MARK	DATE	DESCRIPTIONS	BY	CH'D	CCO#
3	08/29/08	TOWER ANCHORAGE BASE PLATE GROUT	JD	MN	36S1
2	04/03/07	TOWER BASE PLATE	JD	MN	36
1	02/28/07	TOWER BASE PLATE	JD	MN	36

CONTRACT CHANGE ORDER NO. ____
SHEET ___ OF ___

SAN FRANCISCO OAKLAND BAY BRIDGE
EAST SPAN SEISMIC SAFETY PROJECT
SELF-ANCHORED SUSPENSION BRIDGE
(SUPERSTRUCTURE & TOWER)

TOWER ANCHORAGE DETAILS NO. 7

DOWEL ANCHORAGE CONTINGENCY DETAIL (see Note 2)

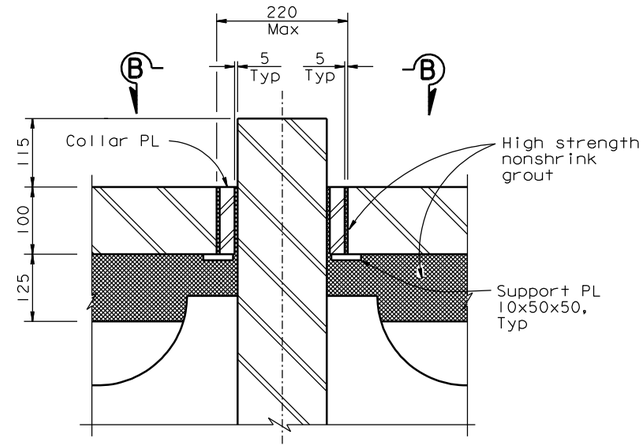
1. For dowel layout, see "Tower Anchorage Details No. 3" sheet.
2. Oversize hole in tower base PL is an acceptable alternative to accomodate tolerance requirements for the erection of the tower base plate. Collar plates shall be A709M Gr. 345 and shall be fabricated based on field measurements and then installed.
3. The Contractor shall recommend an epoxy grout based on manufacturer's recommendations, subject to review and approval of the Engineer.
4. The Contractor may submit alternate dowel anchorage details to suit his erection means and methods, subject to review and approval of the Engineer.

SECTION A-A

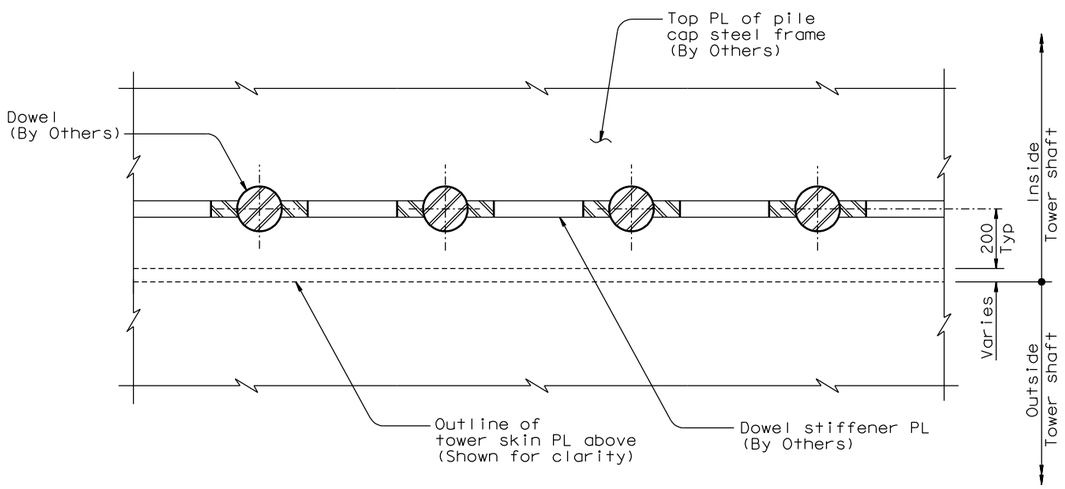
3 High strength nonshrink grout (f'c=104 MPa) (see Note 3)
